Flying Horse North – Phase 2 PUD Parcels 1-6 Preliminary Drainage Report

November 2023

PCD File No. PUD-XXXX **PUDSP234**

EPC STORMWATER REVIEW COMMENTS
IN ORANGE BOXES WITH BLACK TEXT

Figure 2: Existing Tract L Irrigation Pond and Reservoir

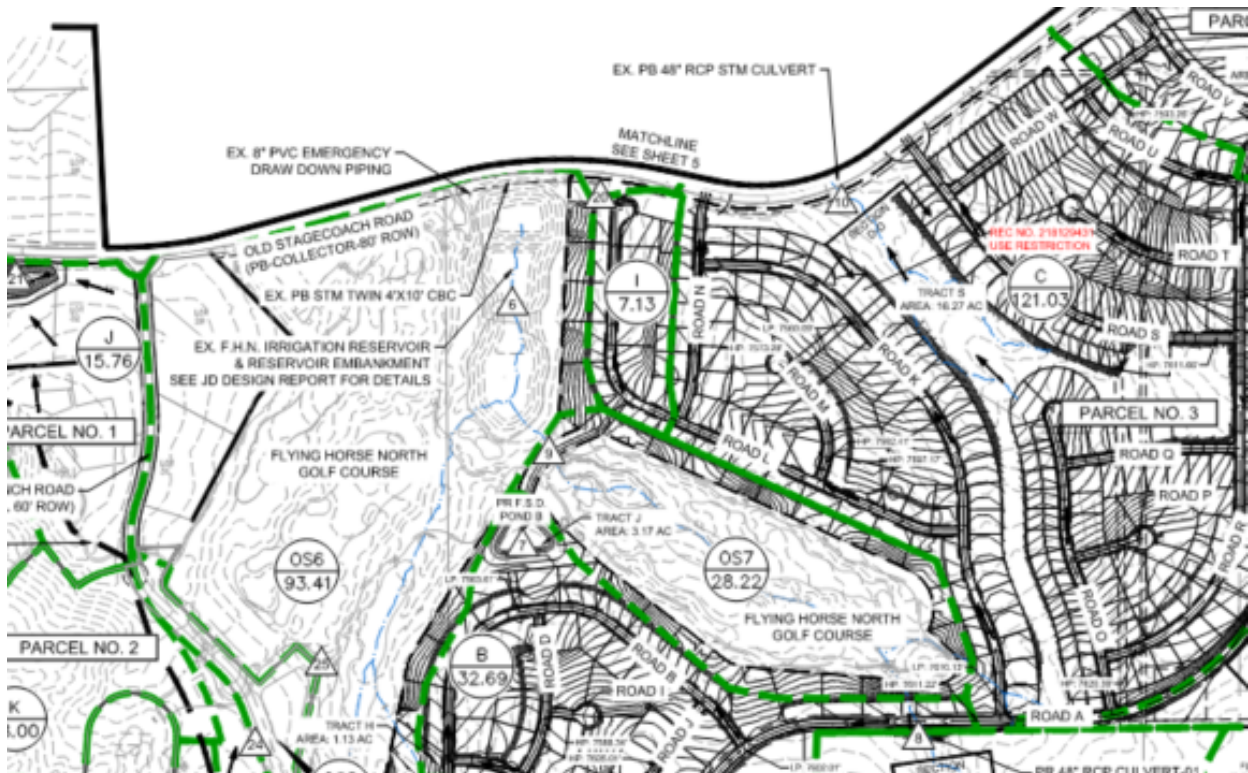
please clarify if the irrigation reservoir is providing detention and water quality for this and any other basin.

Addressed: Basins A1 & A2 have had their basin descriptions revised to explain how detention is being provided by the downstream irrigation reservoir and therefore do not require exclusions. Basin H does not require detention as the entirety of the basin is comprised of 5 acre lots, and per the PBMP applicability form, item E in part II, "large lots" sized greater than 2.5 acres and with less than 10% imperviousness, do not require detention - i.e. large lot exclusion applied. Additionally, an exhibit has been added to the appendix that displays all areas that have been identified as exclusions from detention for one reason or another (large lot applicability, the mentioned code I.7.1.B.7 & I.7.1.C.1) This exhibit also depicts the areas of development/disturbance
